MIDLAND

**SUBJECT: REQUEST FOR ADDITIONAL INFORMATION REGARDING PLANT FILL**

SUBJECT: CORP OF ENGINEERS REPORT AND REQUEST FOR ADDITIONAL INFORMATION  
ON PLANT FILL

SUBJECT: Interagency Agreement No. NRC-03-79-167, Task No. 1 - Midland Plant  
Units 1 and 2, Subtask No. 1 - Letter Report.

Figure 37-1

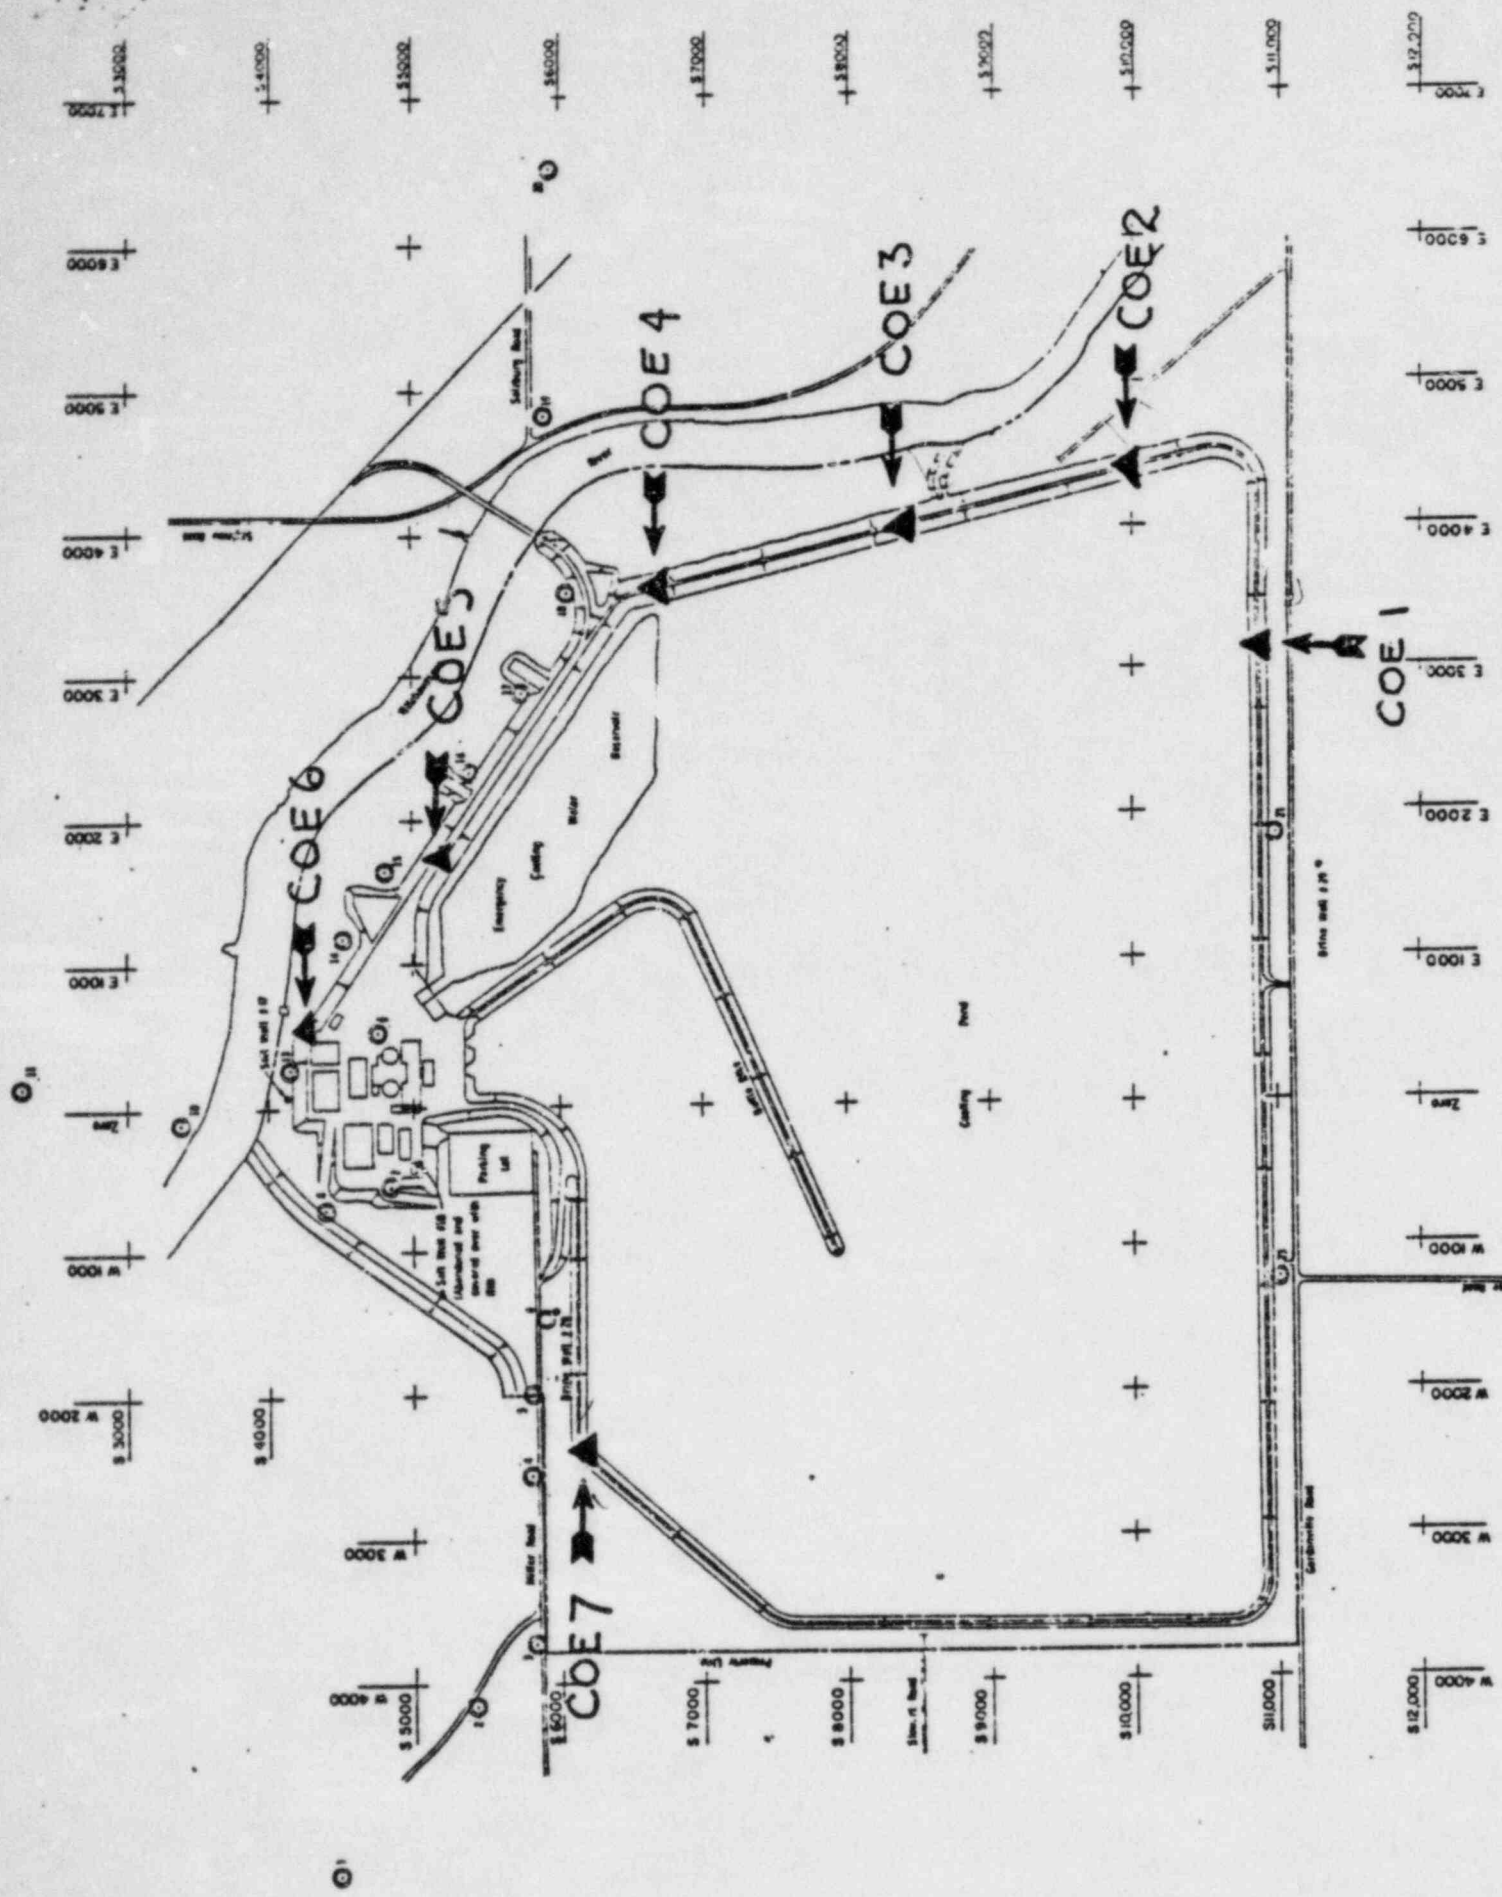
37. (RSP) Your position in previous responses to Requests 5 and 35 not to complete additional explorations, sampling and laboratory testing following the preload program continues to be unacceptable. We require that you complete as a minimum, the exploration and testing program indicated by Table 37-1.
38. Discuss the foundation design for any seismic safety-related piping and conduit connected to or located under the Radwaste Building and Turbine Building where piping and conduit have been placed on plant fill.

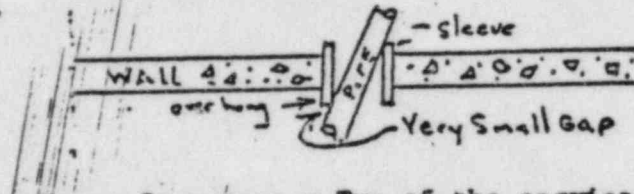
(c) The response to Question 17 of "Responses to NRC Requests Regarding Plant Fill" states that "there is no reason to believe that the stresses in Seismic Category I piping systems will ever approach the Code allowable." We question the above statement based on the following:

$$\sigma_b = 30000 \left( \frac{26}{2} \right) \left[ \frac{8(0.2)(12)}{(20 \times 12)^2} \right] = 130.0 \text{ KSI}$$

*as allowable*
